CUMNOR PARISH COUNCIL
Minutes of the Meeting of the Planning Committee
held on Monday 20 January 2025 at 7.30pm
in Fogwell Road Pavilion, Fogwell Road, Dean Court.

| Ref | Planning application number | Address and proposal. |
|-----|---------------------------------|--|
| i | P24/V2677/FUL + amended details | 75 Cumnor Hill, Cumnor, Oxford OX2 9HX <i>Demolish the existing dwelling and construct 5 new detached houses (3x4 bed and 2x5 bed).</i> Objects.. |

Existing site

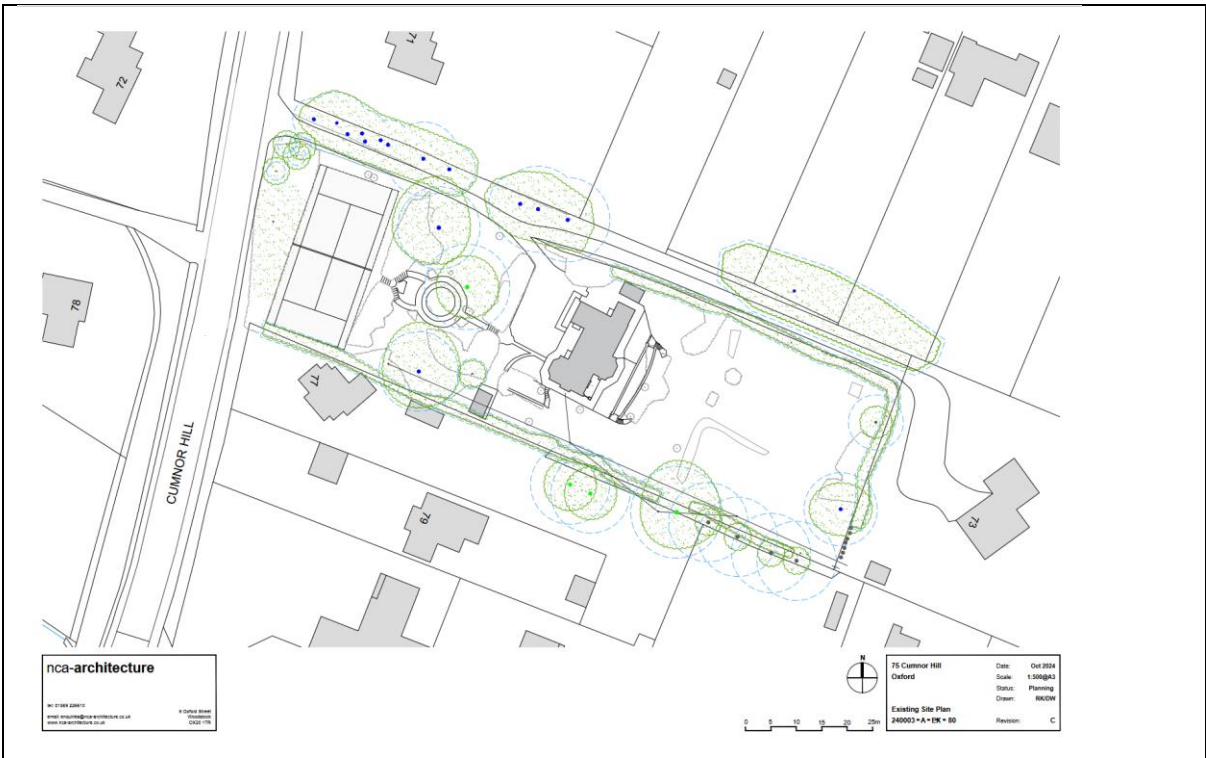
- Although the site is 5.7ha, three of the proposed houses are at a much higher density than is the norm for the area, with separations between buildings of c. 5m between plots 4 & 5, 7m between plots 3 and 4 and less than 5m between plots 2 and 3. Despite the applicant's inaccurate attempt to compare this proposal with the 2014 proposal for Thackery Close (approved before the current Local Plan and the Cumnor NBP), the building to plot ratios for plots 2-4 (with c 60-75% of each plot given over to the building) are out of keeping for the area, both in regards to Neighbourhood Plan policy DBC1 and DBC 3 and Local Plan Policy CP37.

- The close proximity of plots 2-5 means that all windows on facing walls are to be obscured glass, to prevent – as the applicant acknowledges – ‘overlooking’.

- The application includes four areas (marked in red) described as ‘public open space’.
- No details are provided as to what this means – especially pertinent as the application proposes not to build the access road to plots 2-5 to a standard sufficient for it to be ‘adopted’ by the County Council.
- One of the ‘public open spaces’ includes the pond currently in the garden of #75.

It is also proposed that one of the two soakaways for the site be positioned under the garden of plot 1 immediately adjacent to the pavement on Cumnor Hill, with the other situated under the proposed access road to plots 2-5. There's no consideration of effects of soakaway overflow onto Cumnor Hill or the access road.

- Although the application includes a Transport Statement which includes a proposed widening of the current visibility splays where the access road joins Cumnor Hill, no details are provided of any visibility splays at the junction of the access to #73 and the new shared access for plots 2-5.
- In addition, the applicant notes that they do not intend the access to plots 2-5 to be built to the standard required for adopting by the County Council (despite this being a requirement for developments of 5 properties).

This means there is no footpath proposed for access to plots 2-5, or for all of plots 1-5 to access the footpath on Cumnor Hill. Thus pedestrians, for what would be 6 properties (#73 + 5 proposed for #75) would need to access their properties by walking in the access road.

- The Transport statement claims adequate provision for a fire/refuse truck turning circle in the shared access for plot 3 and 4.

However, 'proposed view plot 3' on page 11 of the Design and Access statement shows this area obstructed by a wooden fence and filled by what appears to be a small 3 door car, throwing into doubt the claim of space for a refuse truck.

Proposed site (above) and site section/elevation (below)

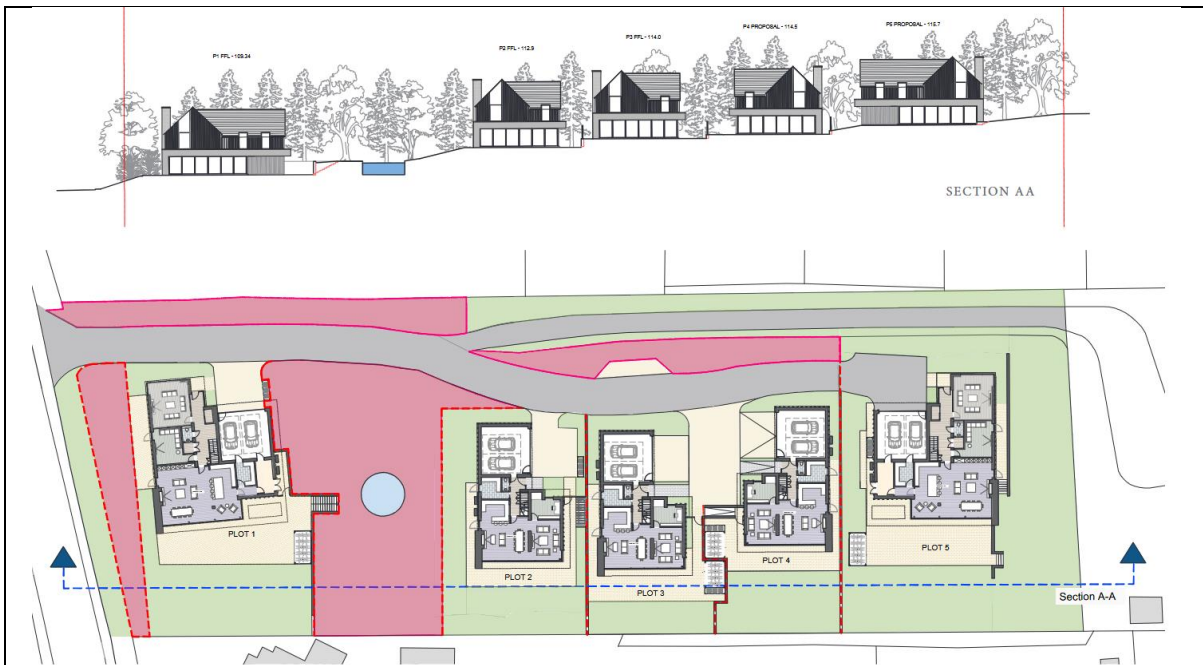
This needs to include the effect on adjoining properties, especially #77, overlooked by Plot 1, which is a Clough Williams-Ellis house - originally the access lodge or gardener's cottage to #85 (Larkbeare), which are both listed in the Cumnor Neighbourhood Plan as Local Heritage Assets (see page 72).

There is inadequate Character Assessment as required by Cumnor Neighbourhood Plan Policy DBC3 – including an assessment of the impact on two 'Arts and Crafts' listed heritage assets in the NBP - #77 (overlooked by Plot 1) & #85 Cumnor Hill - both designed by Clough William Ellis.
